Pulaski County Schools
Energy Savings and Performance Contract
Addendum #2
March 25th, 2022

CMTA Contact:	Megan Brangers
Email:	MBrangers@cmta.com
Cell Phone:	502-919-1521

The following information supersedes or is in addition to information released in the Contract Documents dated March 11th, 2022 and addendum 1 dated March 18th, 2022.

M2-5.0

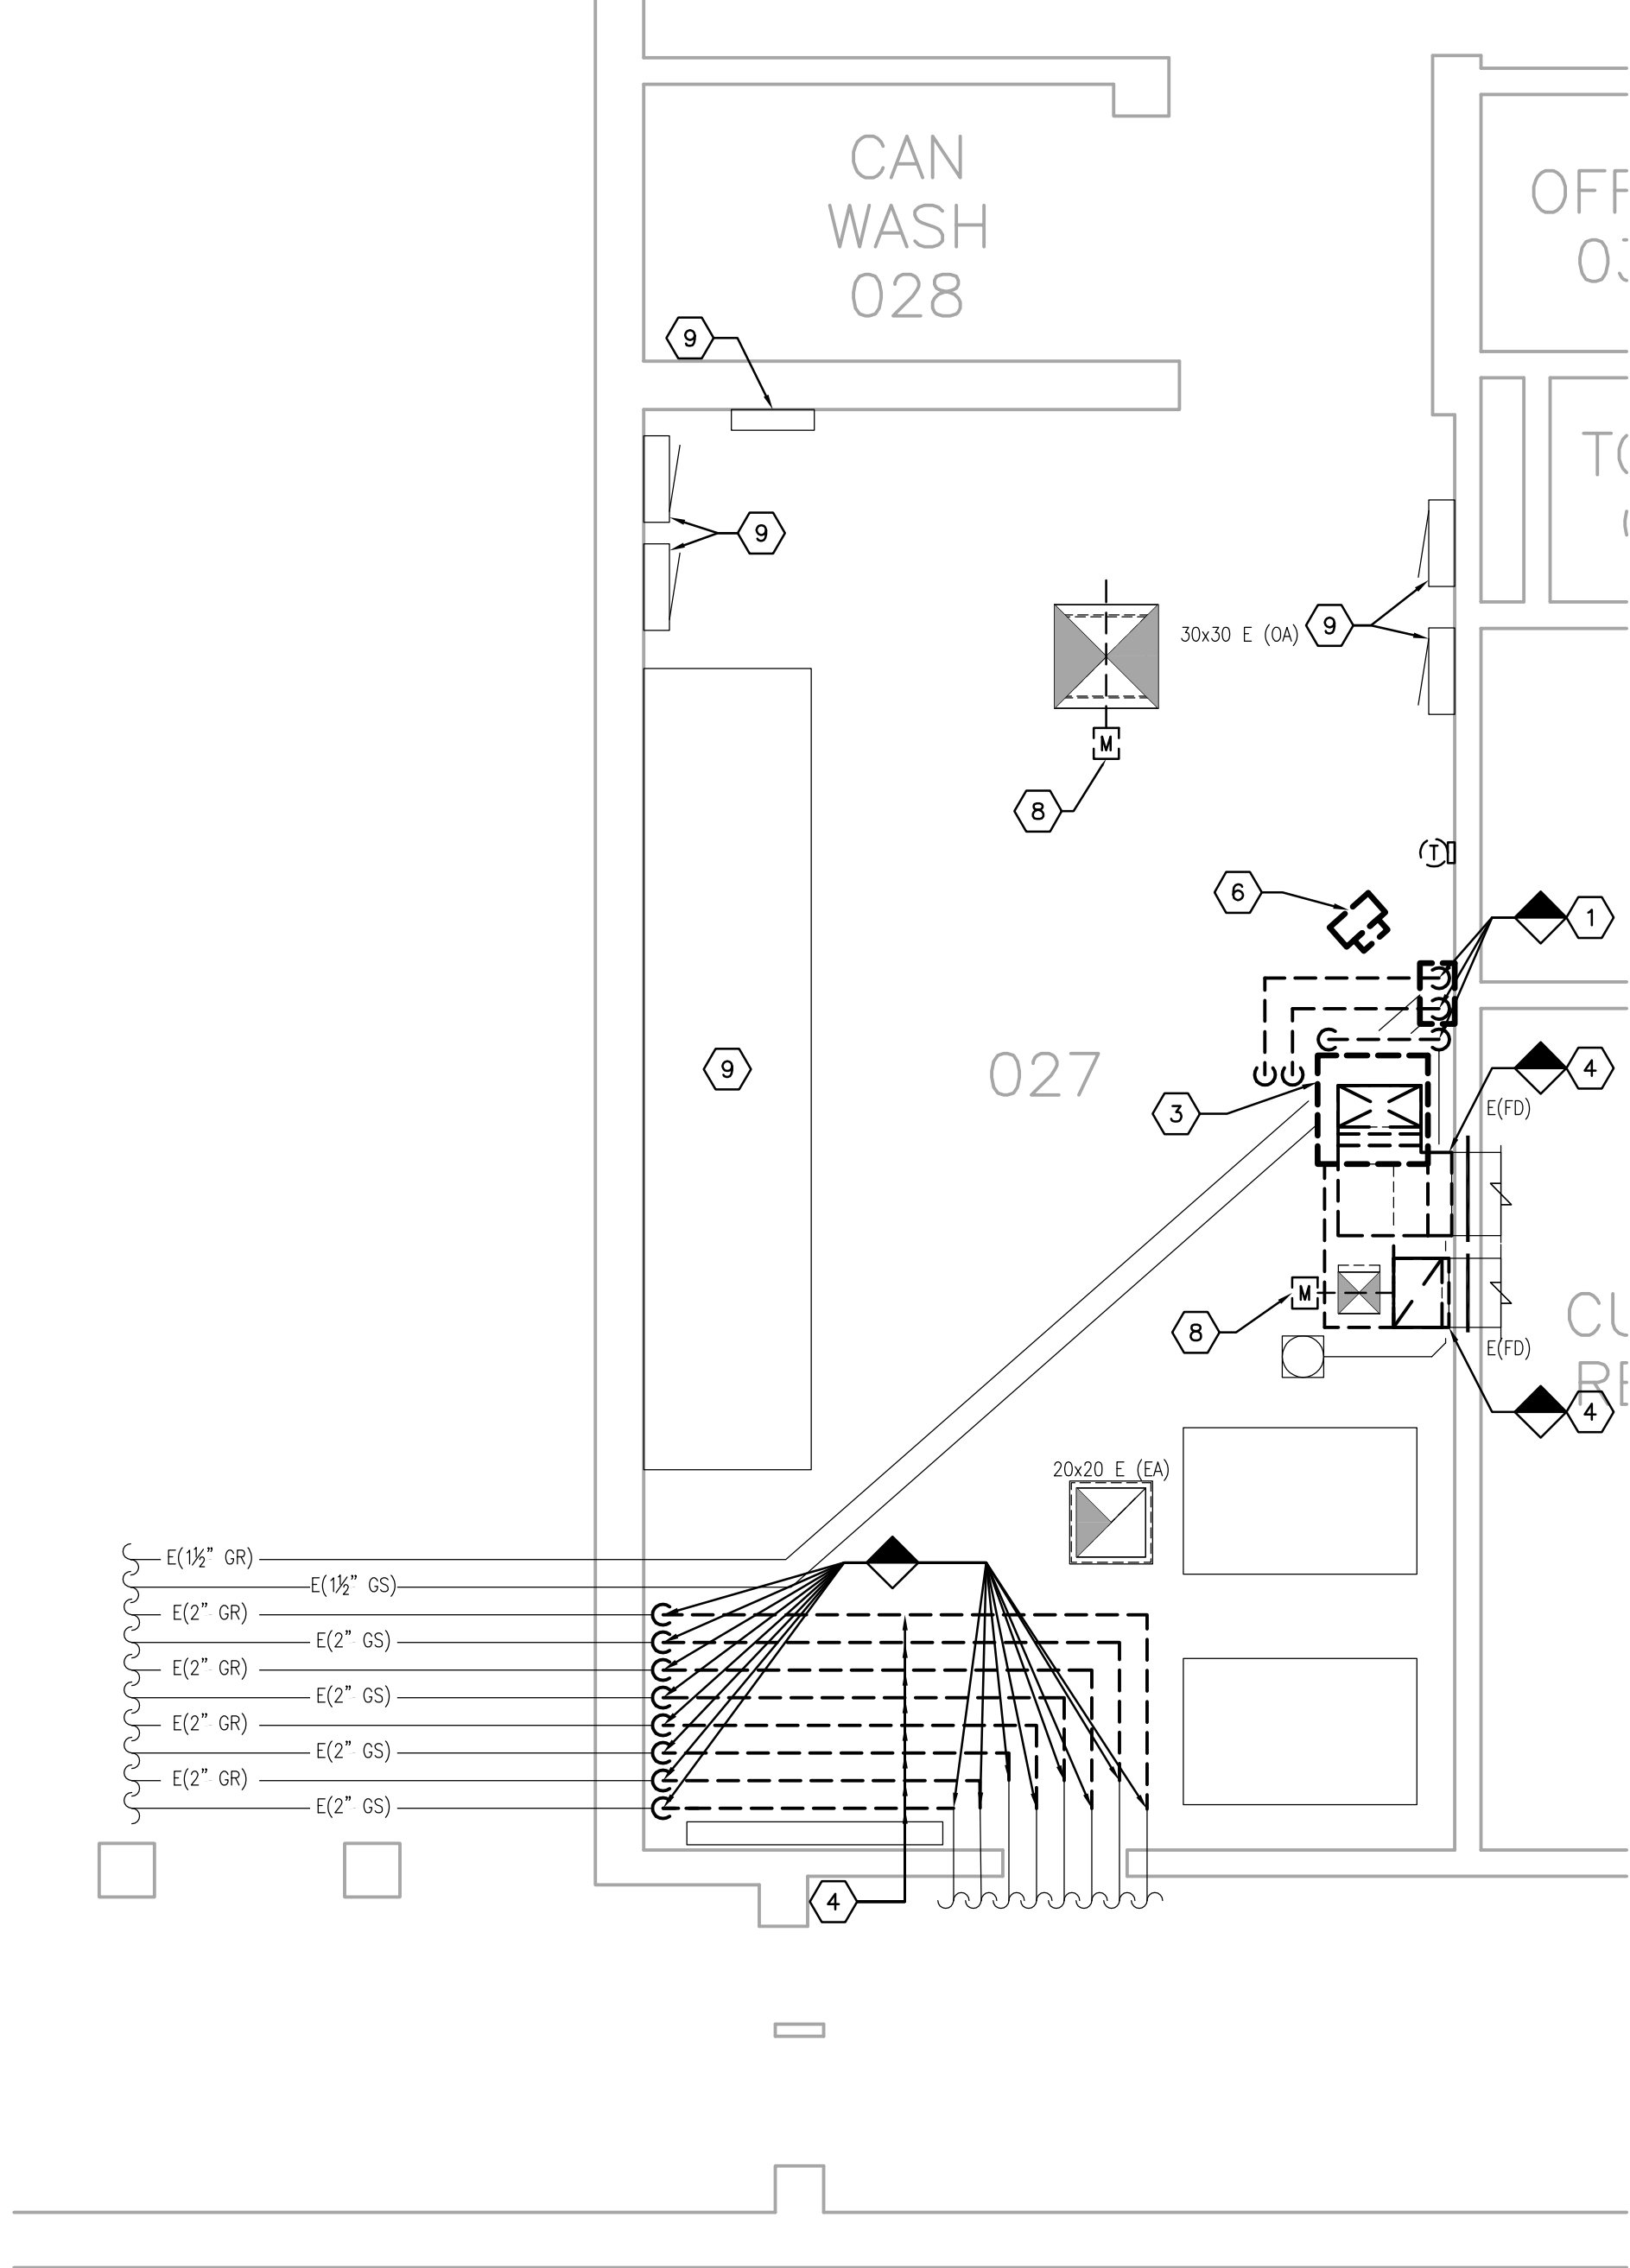
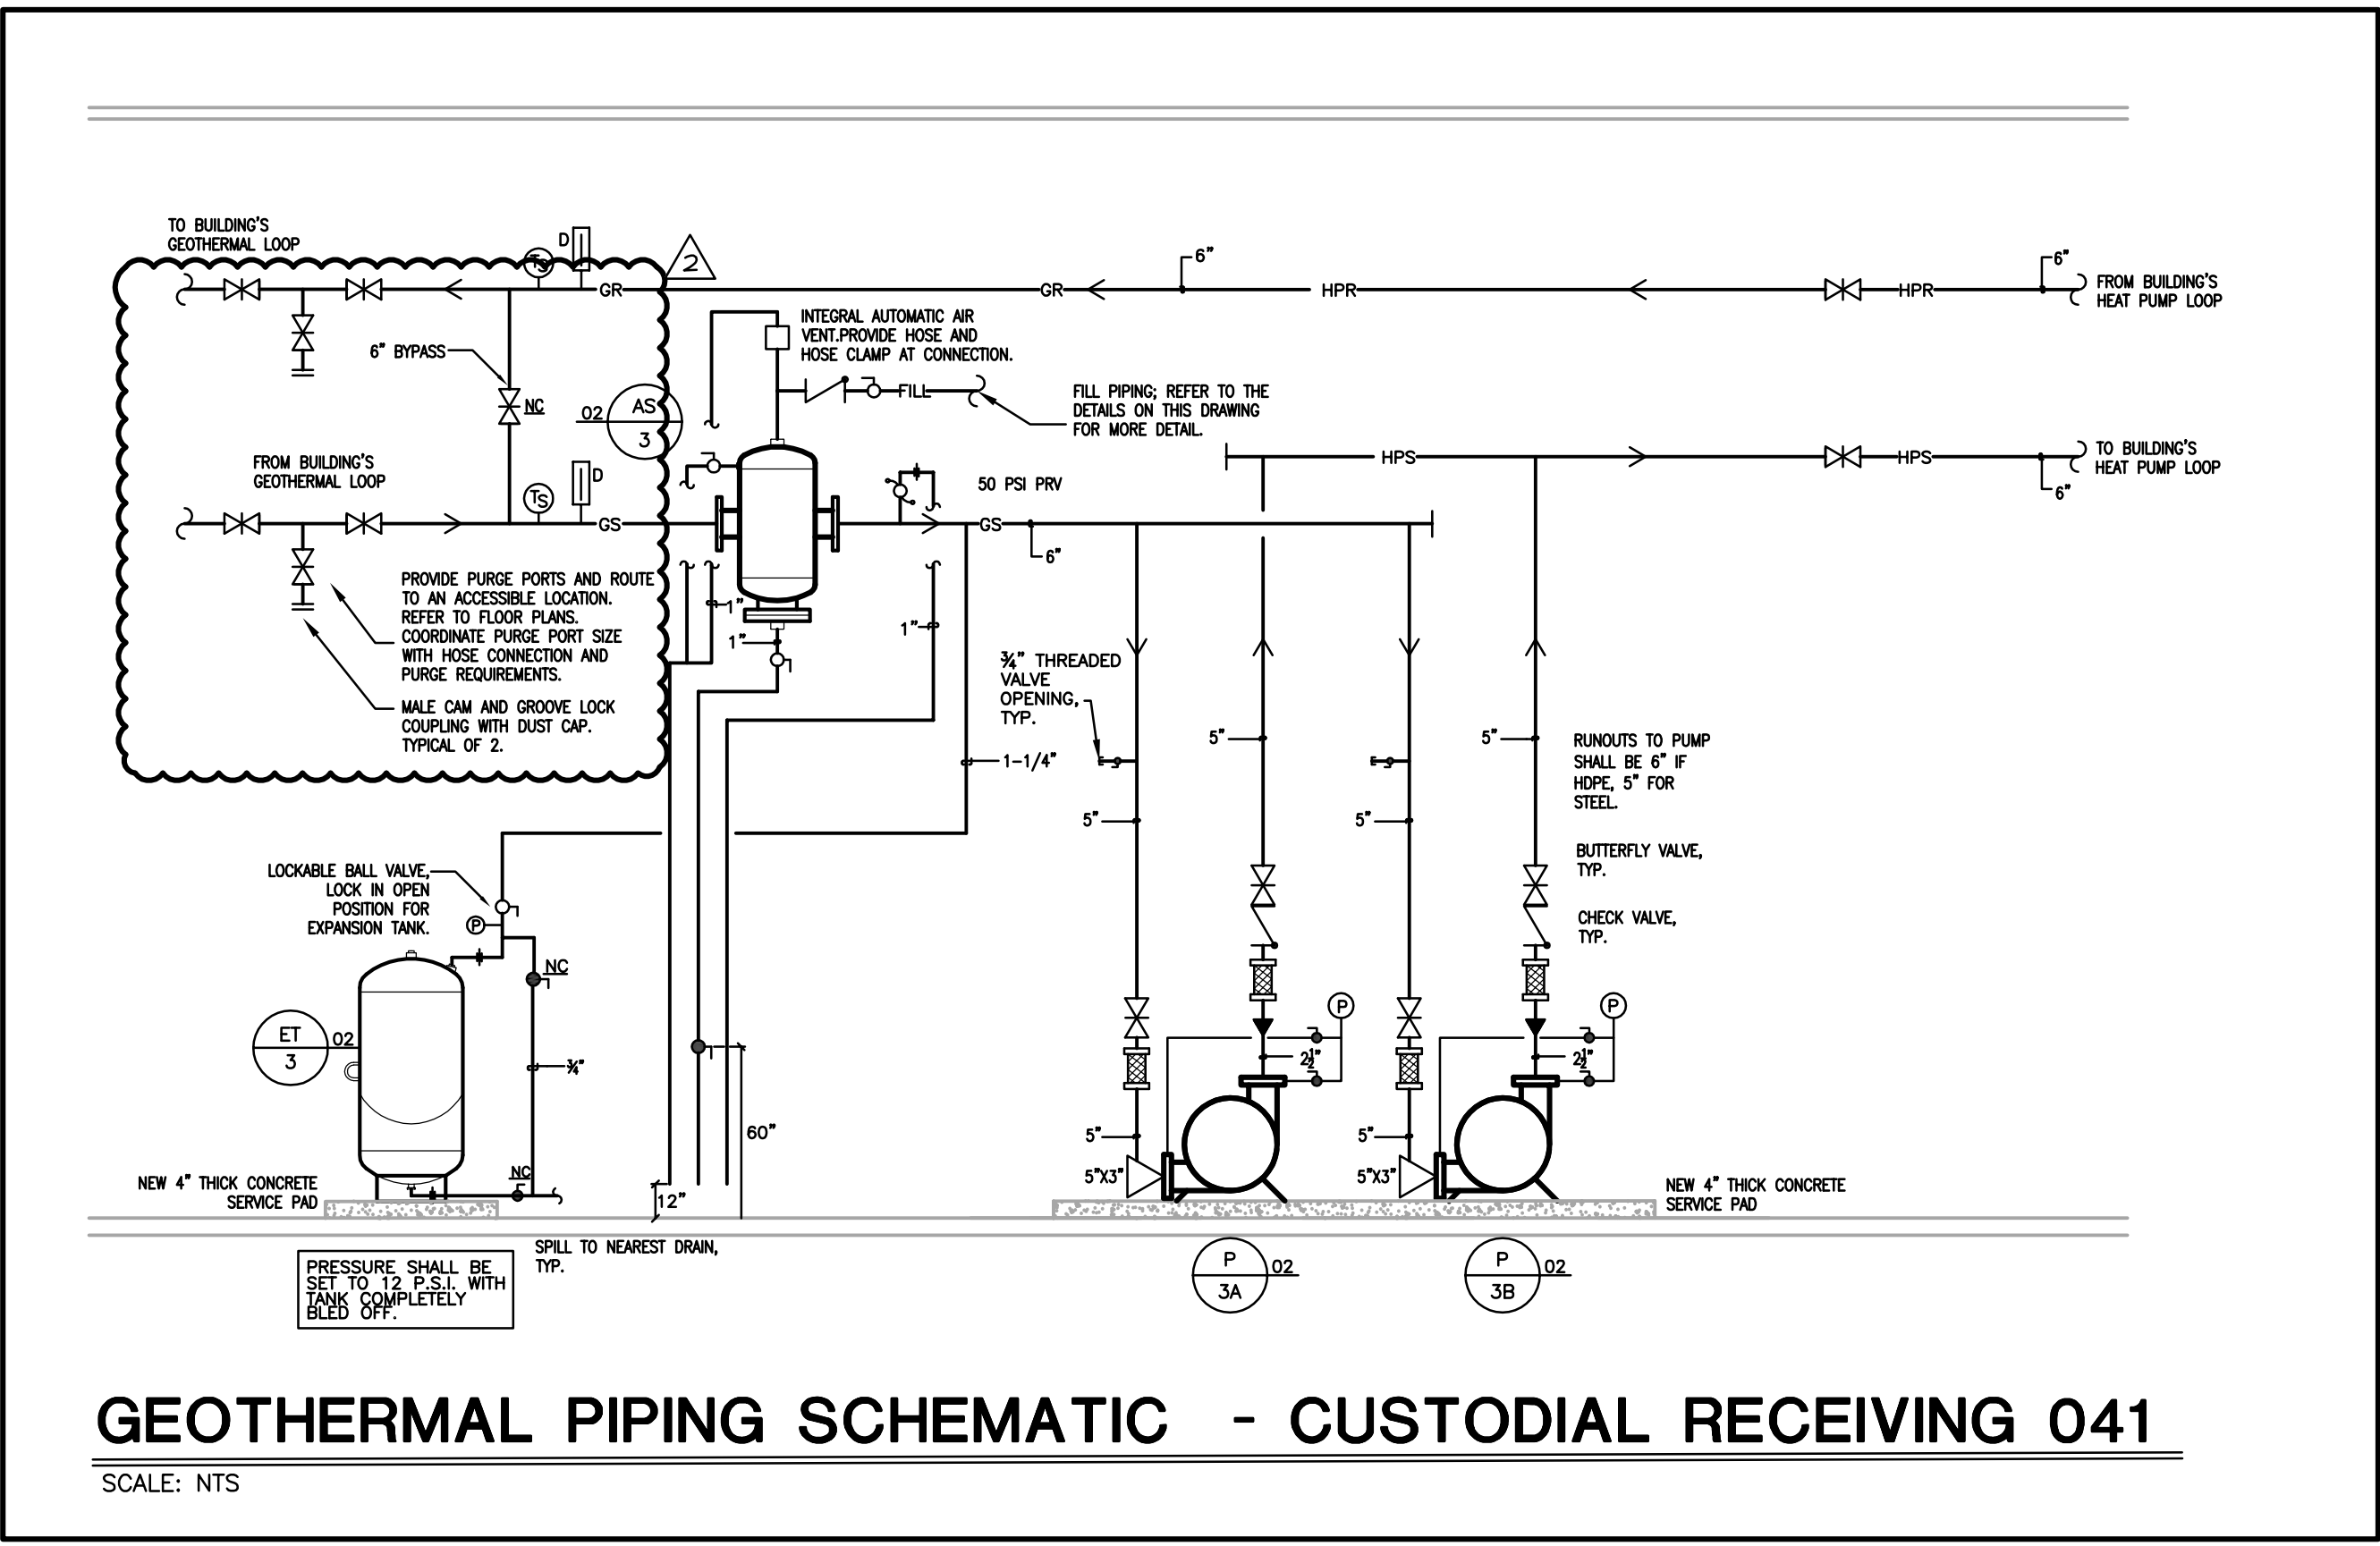
14. Drawing M2-5.0

- a. Refer to Mechanical Room 027 for revised geothermal and heat pump piping. Add geothermal wellfield bypass and purge ports. Add 5-gallon pot feeder.
- b. Refer to Custodial Receiving 041 for revised geothermal and heat pump piping. Add geothermal wellfield bypass and purge ports.
- c. Refer to 'Geothermal Piping Schematic - Custodial Receiving 041' for updates. Add geothermal wellfield bypass and purge ports.
- d. Refer to 'Geothermal Piping Schematic - Mechanical Room 027' for updates. Add geothermal wellfield bypass and purge ports. Add 5-gallon pot feeder.
